Statement of Environmental Effects Section 4.55 Modification Application to DA-357/2020

Application Number: DA-357/2020

Property Address: **17 Starr Avenue, Padstow NSW 2211**
Lot: Lot 7 DP 30072

- Change the façade

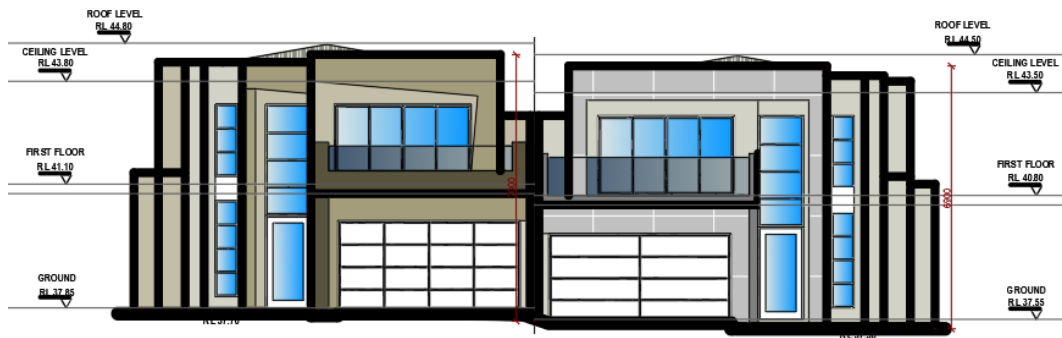
Façade has been simplified for construction reasons but no changes to the heights or envelope. The changes are limited to the parapet shape, entry door and face bricks

- Changes to the rear

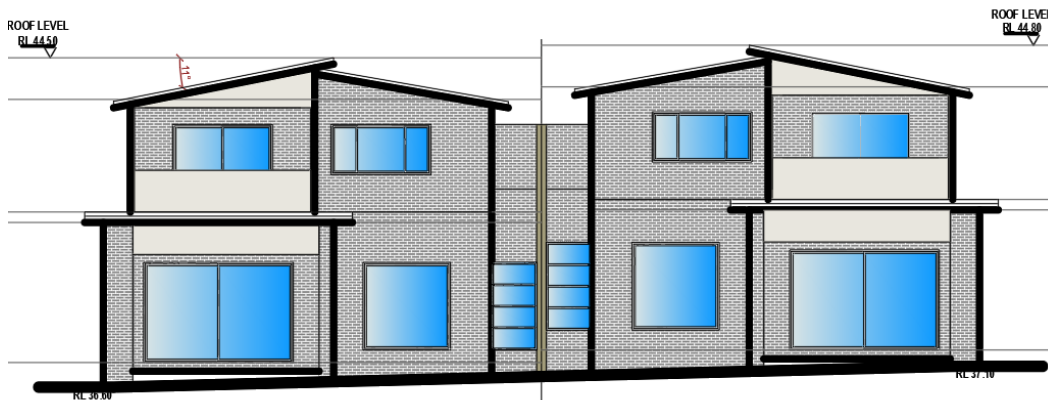
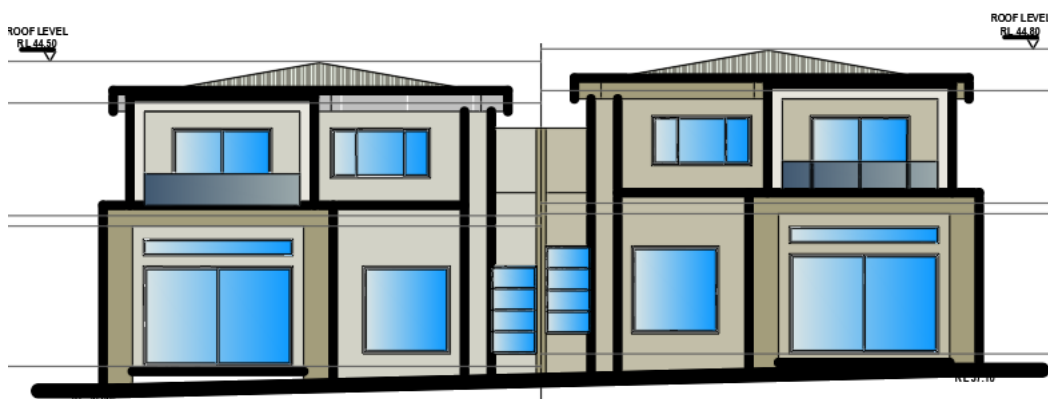
Limited to the roof as parapet was not the preferred construction method and face bricks
